RE: IDNR Permit C20220006
USACOE LRC-2021-454

Dear Mr. Casey and Mr. Hall:
Please enter the letter below from Winnetka Village President, Chris Rintz, into the public record and the file for the LRC-2021-00454 Winnetka Elder Centennial beach permit application.
Thank you,
Laurie Morse

Public Comment for Project Number LRC-2021-00454

Top of wall is 13 feet
above sand level

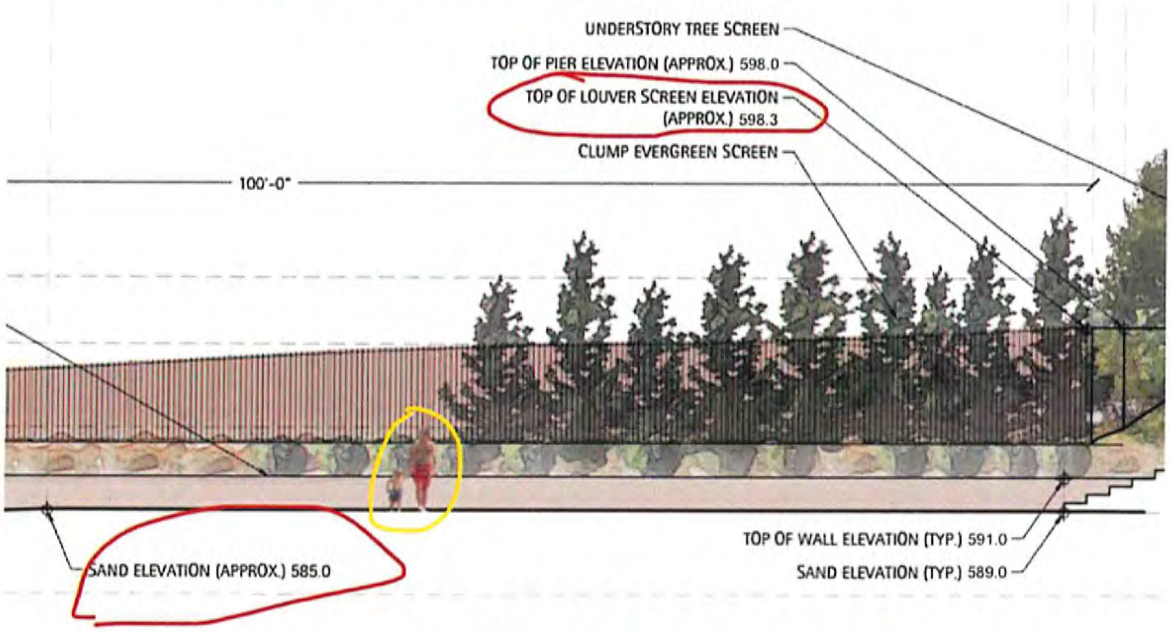
We see no reason why we can't have the same type of breakwater as Lloyd. It would preserve the continuous shoreline view, access and be a far more natural landscape.

Top of wall is 13 feet
above sand level

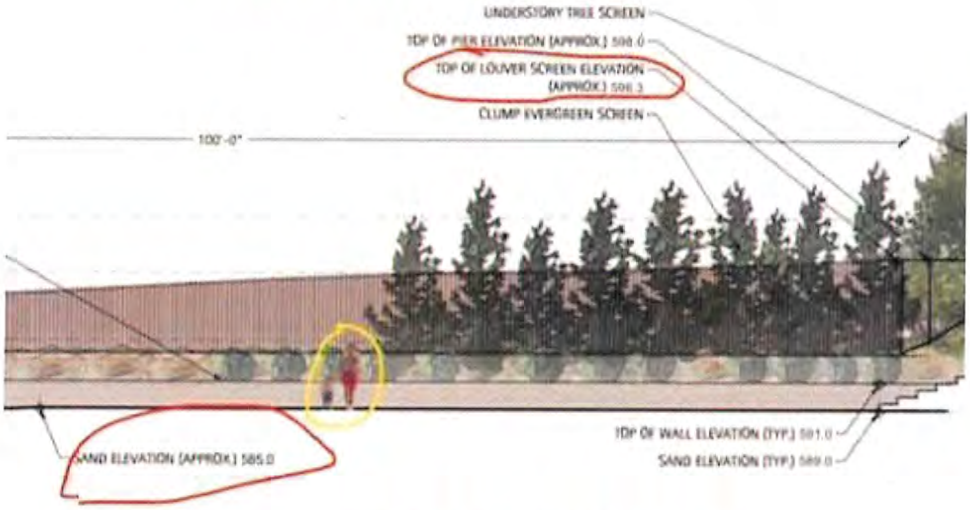
I am writing to augment my email of May 15th. It appears that, subsequent to receiving letters of support from various elected officials, the Winnetka Park District and Orchard 2020 Trust significantly modified the original 2030 plan for the combined Elder + Centennial Beach. The approved 2030 plan has been changed by adding significant permanent planting on the beach and a "steel louvered air screen" that would rise 13 feet above the elevation of the beach, would block beach access, and would block all views north and south of the combined public beach:

To my knowledge the proposed "Steel louvered air screen", which would extend from the base of the bluff to the shoreline, was not part of the original 2030 plan for the combined Elder + Centennial Beach, nor has it ever been used on any other beaches on the North Shore. It is unproven, and if this element of the plan is approved, could set a dangerous precedent for other Public Beaches to become walled in. I believe such a move is in violation of the Illinois Public Trust Doctrine. Frankly, the walled in aspect of the design appears to benefit the adjacent private land owners, at the expense of the tax paying village residents who want to enjoy a Public Park, and its prime location on a beautiful Public Beach.

FIGURE 1: VIEW LOOKING NORTHEAST FROM ORCHARD 2020 BLUFF TOE

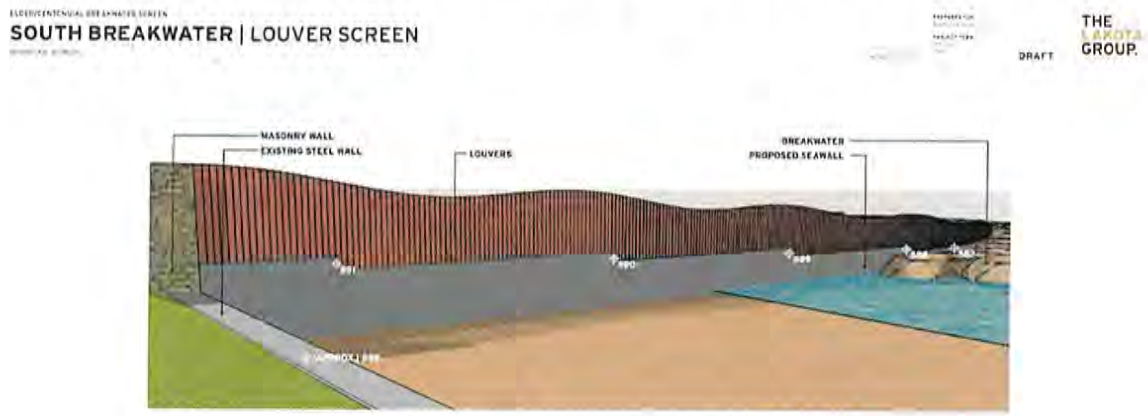
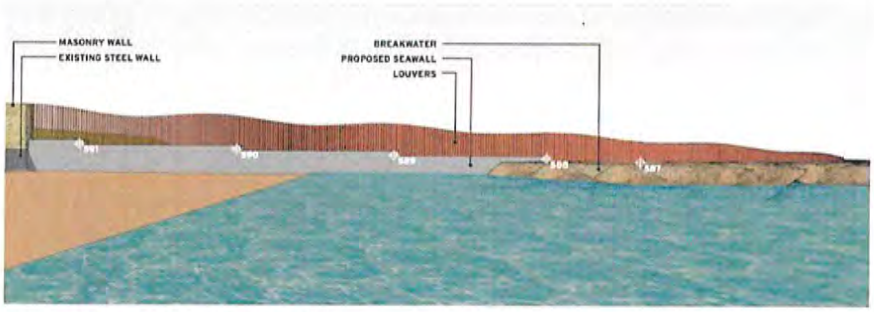
In case you have not seen the design, here are two renderings from the consultant working on the project. I hope you will agree that this project has no place on our public beaches.

FIGURE 1: VIEW LOOKING NORTHEAST FROM ORCHARD 2020 BLUFF TOE

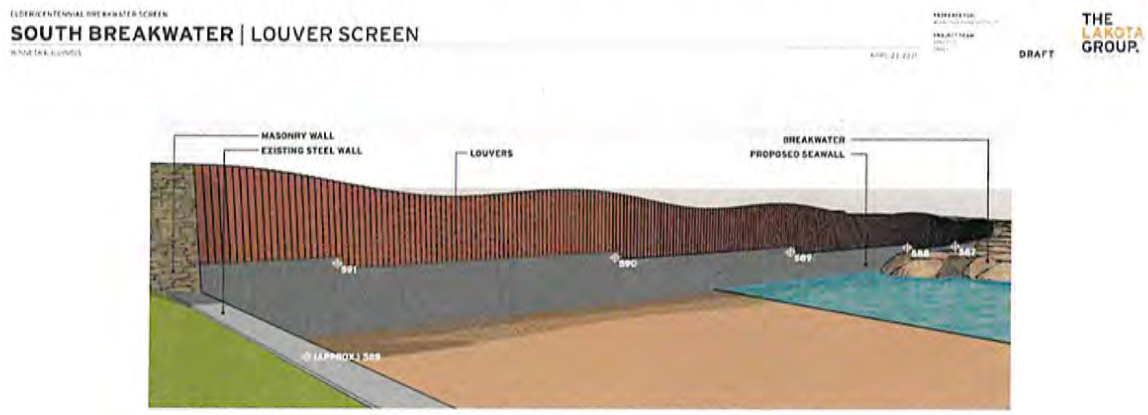
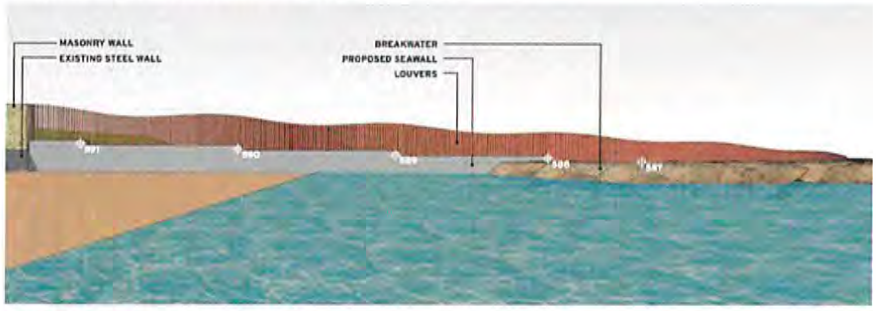
In case you have not seen the design, here are two renderings from the consultant working on the project. I hope you will agree that this project has no place on our public beaches.

FIGURE 1: VIEW LOOKING NORTHEAST FROM ORCHARD 2020 BLUFF TOE

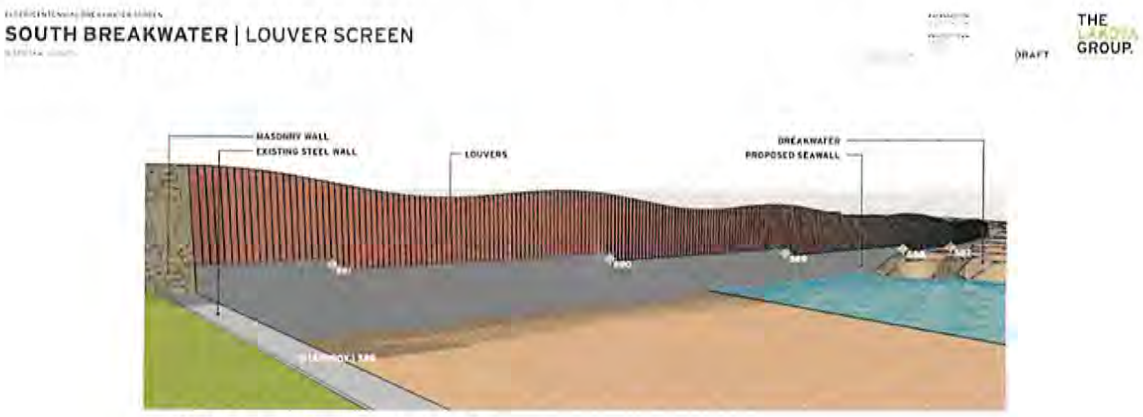
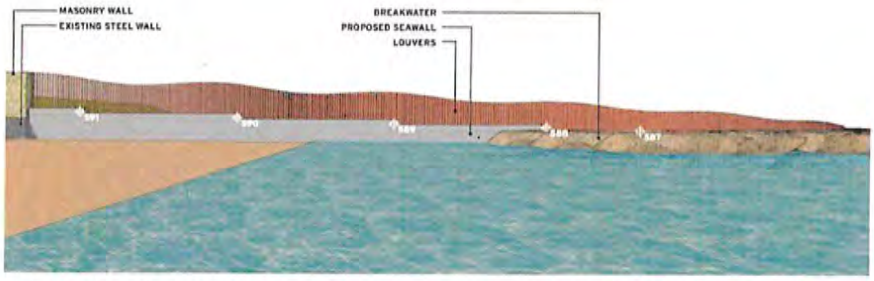
In case you have not seen the design, here are two renderings from the consultant working on the project. I hope you will agree that this project has no place on our public beaches.

Shabica figures 4 and 7 annotated to show heights relative to a 6 foot high stick figure.

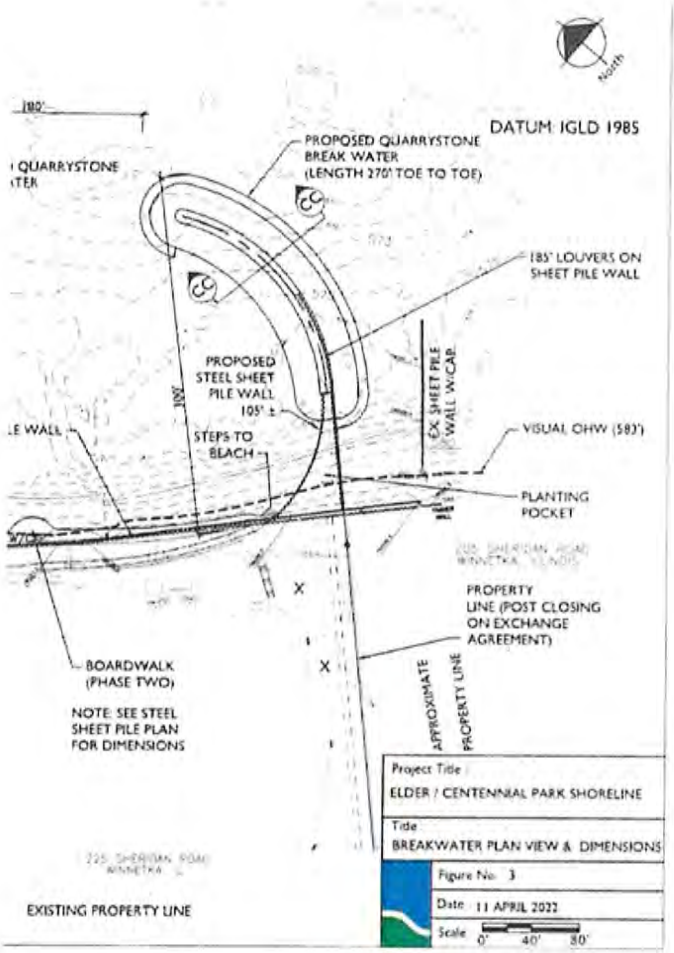
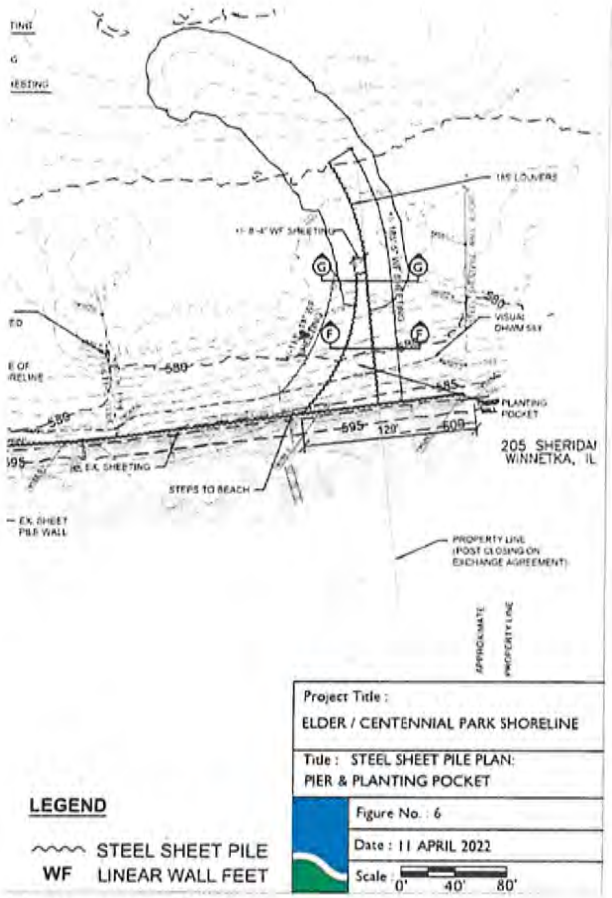
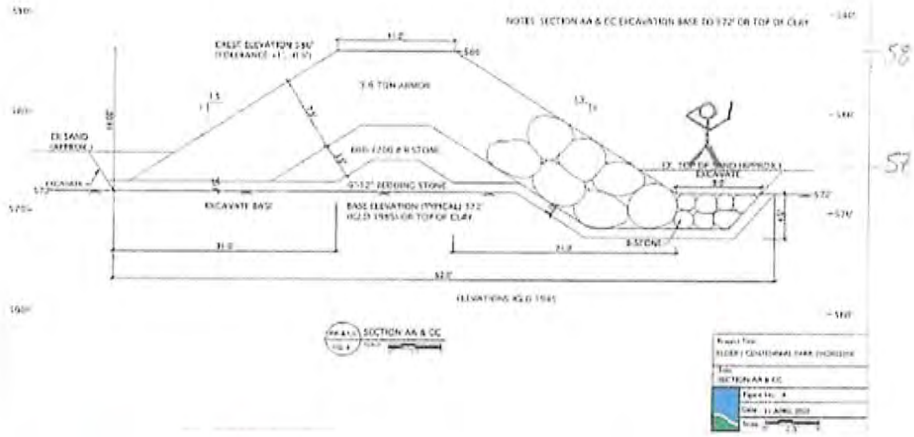
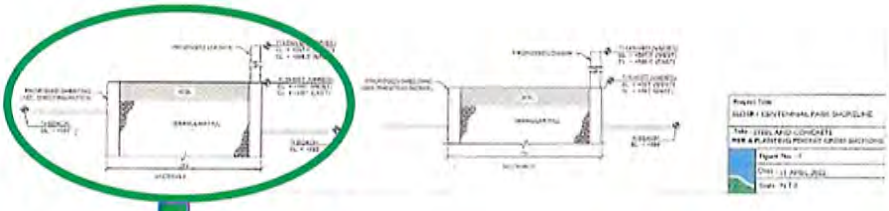
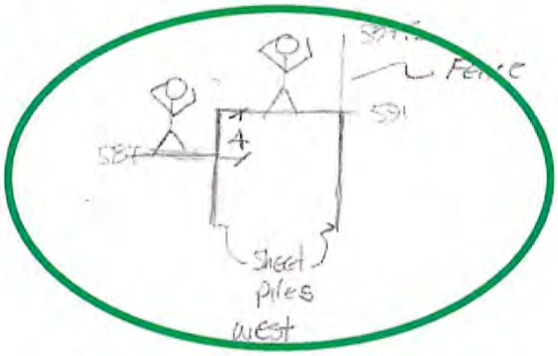
1) If the breakwater is built as shown – without specifically designed
   - access stairs over the boulder rip rap in cross section CC shown in Shabica Figures 3 and 4 below on page 4 or/and
   - passage over planter pocket, and through lovers shown in cross sections FF and GG in Shabica Figures 6 and 7 below on page 5 with annotations

a. No cross section similar to CC of the breakwater is provided that contains a stairway design.
      i. Why is such a detailed design not required?
      ii. This breakwater essentially is a 4.5 foot high rubble stone wall at OHWM of 581.5 and 11 feet high at lake elevation of 575 shown on Shabica Figure 4 and that blocks beach access as shown on the attached cross section CC annotated with the addition of a 6 foot high person for scale.

ii. This planter pocket is essentially is a 4 foot high rubble stone wall at beach elevation 587 as drawn in Shabica Figure 7. A Shabica Figure 7 cross section FF (with appropriate heights) is annotated with the addition of a 6 foot high person for scale.

c. No cross section similar to FF and GG of the louver fence is provided that contains an opening for lateral beach access.
   i. Why is such a detailed design not required?
   ii. This louver/fence is essentially another 6.5 foot high barrier at beach elevation 587 as drawn in Shabica Figure 7. A Shabica Figure 7 cross section FF is annotated with the addition of a 6 foot high person for scale.
